GG119 ROAD SAFETY AUDIT RESPONSE REPORT

Project Title:	Woodward Court, Mirfield
Project Team:	Optima Highways and Transportation Ltd
RSA Report Stage	Stage 1
RSA Organisation:	Road Safety Initiatives
RSA Report Reference:	RSI-MM-0626-006 Issue 1.0
RSA Report Issue Date:	1 st July 2026
Report Title:	Response to Woodward Court, Mirfield, Stage 1 Road Safety Audit
Reference:	260706 Woodward Court, Mirfield – RSA Stage 1 Response Report

This Road Safety Audit Response Report relates to a Stage 1 Road Safety Audit carried out in Mirfield on the proposed residential development access junction in Hepworth Lane, a residential access in Woodward Court and associated improvements in Wellhouse Lane (Planning Application Reference 2025/93355). The objective of the scheme is to provide access to a development of up to 75 residential dwellings. Full details of the scheme can be found within the Road Safety Audit Brief dated 17/06/2026.

2.1.3 Problem

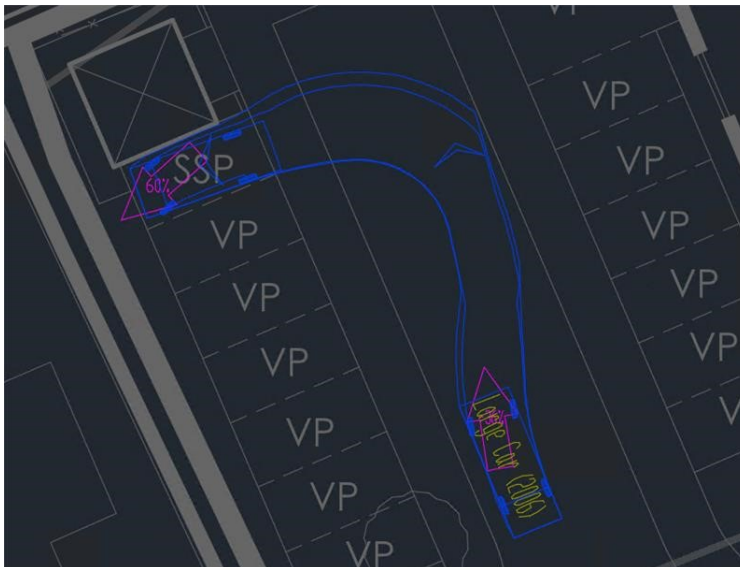
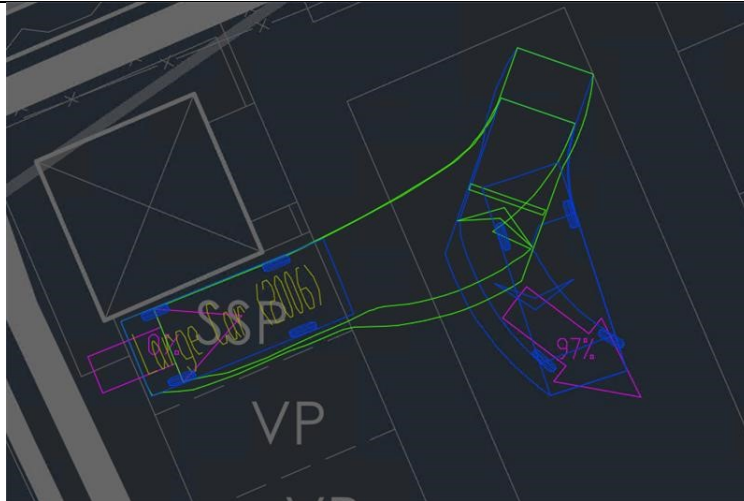
Location: Woodward Court – small car park.

Summary: Reversing vehicle hazard for pedestrians.

Detail: Car access to some of parking spaces looks difficult, noting that the car park does not include a turning head. If some drivers need several reversing movements to access the end parking bays, this would be a hazard to pedestrians walking through the car park to / from the public footpath

Recommendation: It is recommended that there is swept path analysis of each space in the car park and that the layout is modified where needed, so to reduce the likelihood of multiple reversing manoeuvres simply to get into a parking space.

The recommendation is acknowledged and accepted. Swept path analysis has been undertaken for the furthest parking space as the car park has evolved since the RSA. The swept path demonstrates that the bay can be accessed without excessive manoeuvring.

Given the limited scale of the car park and the low vehicle flows anticipated, as well as the provision of 2.0m footways around the car park, the likelihood of conflict between vehicles and pedestrians is very low.

The RSA Problem and Recommendation are accepted, and Design Team Response is partially accepted. However, HDM request that the parking spaces be designed at 2.5 x 5.0m per space, to assist with manoeuvring and space utilisation during busy school drop-off/pick-up periods. 0.6m wide margins should also be provided around the spaces (including adjacent to the sub-station), to take account of vehicle overhang and ensure vehicles do not overhang into the footways.

Parking spaces provided at 2.5x5.0m (noting they were always shown as 2.5m x 5.0m) and, following further discussions, 0.45m grass margins to be incorporated – as shown on Rev D of the updated Drawing 25033/GA/02.

2.2.2 Problem

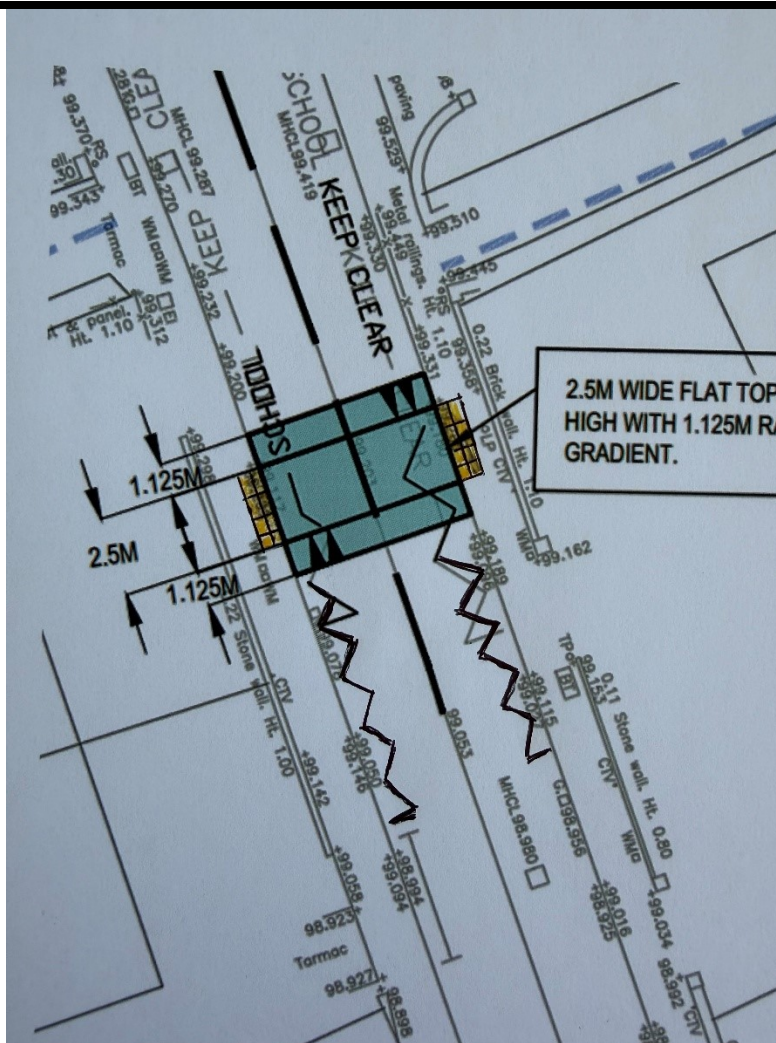
Location: Speed tables and junction table in Wellhouse Lane.

Summary: Possible pedestrian / vehicle conflicts at informal crossing locations

Detail: One of the four speed tables (outside school pedestrian access) will be provided with a pedestrian crossing point. Two of the other three speed tables are likely to be used as informal pedestrian crossing points, being in proximity to the school. However, on-street parking, particularly at school opening and closing times, is likely to restrict visibility for pedestrians attempting to cross Wellhouse Lane on the speed tables. Pedestrian / vehicle conflicts are possible

In addition, the proposed junction table at Wellhouse Lane / Woodward Court lacks a pedestrian crossing point on its South side. This would be useful location for a crossing, as the western footway terminates South of this T-junction

Recommendation: It is recommended that a single yellow line (and TRO) or an extended SCHOOL KEEP CLEAR marking are used to prevent parking at or near two of the speed tables (Outside No. 66 and near PROW MIR/16/20). It is also recommended that crossing points with tactile paving are provided at these two speed tables and on the South side of the Wellhouse Lane / Woodward Court junction table.

An extended SCHOOL KEEP CLEAR marking has been provided adjacent to PROW MIR/16/20, together with a crossing point incorporating tactile paving.

A crossing point with tactile paving has not been provided at the speed table outside No. 66. Pedestrians are able to cross at the other formal crossing points proposed located to the north and south, and an additional crossing facility at this location is not considered necessary (and one does not exist now). The speed table is intended primarily as a traffic calming feature rather than a pedestrian crossing point and does not align with established pedestrian desire lines, existing Public Rights of Way or a direct access to the school. Additional parking restrictions have also not been introduced at this location, as they would displace on-street parking elsewhere on Wellhouse Lane.

Although a crossing on the southern side of the Wellhouse Lane / Woodward Court junction table was not considered essential due to the proposed crossing on the northern side, the design has been amended to include a crossing point with tactile paving on the southern side of the junction table on 25033/GA/02 Rev D.

The RSA Problem and Recommendation is generally accepted (but not the recommendation associated with the speed table near to No. 66), and the Design Team response is accepted.

However, the Councils Highway Safety Team have highlighted that the extended School Keep Clear markings that have been indicated in the above sketch may not be in full accordance with the Traffic Signs Manual (TSM Chapter 3 – Section 13.28), which is prescriptive in terms of the standard length of markings and maximum total lengths of markings that are permitted. Therefore, the plans should be checked to ensure compliance and updated to comply with the maximum length permitted in TSM as necessary. The final extent of School Keep Clear markings will then need to be determined at the detailed design stage, following the consultation with local residents, as required as part of the associated TRO process.

- Dropped crossing and tactile paving at the proposed speed table within the vicinity of PROW MIR/16/20.
- Indicative proposals for the extension of School Keep Clear markings within the vicinity of the new dropped crossing near to PROW MIR/16/20 to improve visibility at the crossing point, with the final details to be agreed at the detailed design stage following the TRO consultation process.
- Dropped crossing and tactile paving provided on the south side of the Wellhouse Lane / Woodward Court junction.

2.2.3 Problem

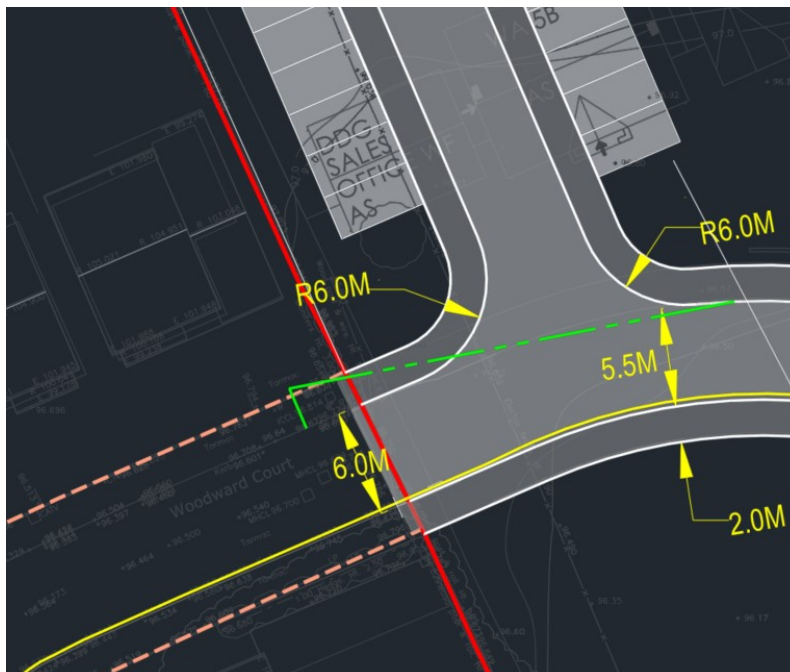
Location: Woodward Court Extension

Summary: Potential for 'vehicle-to-pedestrian' incidents associated with restricted visibility.

Detail: Following the proposed extension of Woodward Court, visibility from an existing drive (7 Woodward Court) may be inadequate, because there is a close-boarded fence. Conflicts involving vehicles emerging and people / traffic from the new estate are possible.

Recommendation: It is recommended that adequate visibility is achieved. This could be achieved by realigning the carriageway or by land purchase or by removal of part of the boundary fence.

In accordance with *Manual for Streets (MfS)*, a setback of 2.4m from the edge of the carriageway can achieve a 25m visibility splay, which is appropriate for a 20mph speed limit.

MfS also recognises that a reduced setback of 2.0m may be acceptable in lightly trafficked, low-speed environments, stating:

“A minimum figure of 2m may be considered in some very lightly-trafficked and slow-speed situations, but using this value will mean that the front of some vehicles will protrude slightly into the running carriageway of the major arm. The ability of drivers and cyclists to see this overhang from a reasonable distance, and to manoeuvre around it without undue difficulty, should be considered.”

The RSA Problem is accepted, and the RSA Recommendation is partially accepted. The Design Team response is accepted, which confirms that adequate visibility will be available to/from the private drive with a set-back distance of 2m, which is adequate in this situation.
